Building Manager: [John Cochran, john.cochran@oregonstate.edu](mailto:john.cochran@oregonstate.edu)  
 Assessment Date: 3/15/2022  
 Assessment Number: **10558**  
 Location: Johnson Hall Entire  
 Reinspection date:

A joint fire safety inspection of the facility listed above was performed by the Environmental Health & Safety - Fire and Life Safety and the Corvallis Fire Department. These fire safety deficiencies could result in a fire or jeopardize the safety of those occupying the facility. Please see that these items are corrected immediately and no later than the scheduled reinspection date noted with this report. If you have any questions regarding this inspection, please email Brian Lilley (EH&S - Fire and Life Safety) at [brian.lilley@oregonstate.edu](mailto:brian.lilley@oregonstate.edu).

Hood 203 Bench 200z

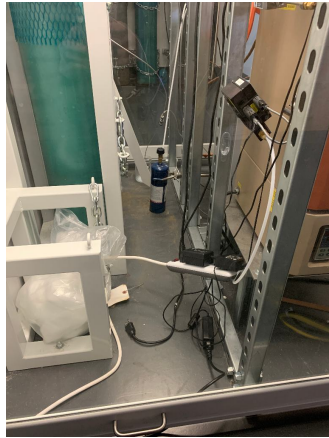
<b>Priority code</b>	<b>Standard in need of attention</b>	<b>Reg.Reference</b>	<b>Location</b>	<b>Resp</b>	<b>Observations &amp; Recommendations</b>	<b><a href="#">Date Corrected</a></b>
2	Power strips, extension cords, or any other electrical cord shall not extend through walls, ceilings, floors, under doors or floor coverings, or be subject to damage.	2019 OFC 604.5	Bench 200Z:Hood 203	DEPT DEPT DEPT	Remount hanging power strip according to manufacturer's instructions.	
2	Power strips, extension cords, or any other electrical cord shall not extend through walls, ceilings, floors, under doors or floor coverings, or be subject to damage.	2019 OFC 604.5	Bench 200x:floor	DEPT DEPT DEPT	Provide ground protection (cord protector) for gas line tubing and/or wiring.	
2	Power strips, extension cords, or any other electrical cord shall not extend through walls, ceilings, floors, under doors or floor coverings, or be subject to damage.	2019 OFC 604.5	Bench 206x:floor	DEPT DEPT DEPT	Provide ground protection (cord protector) for gas line tubing and/or wiring.
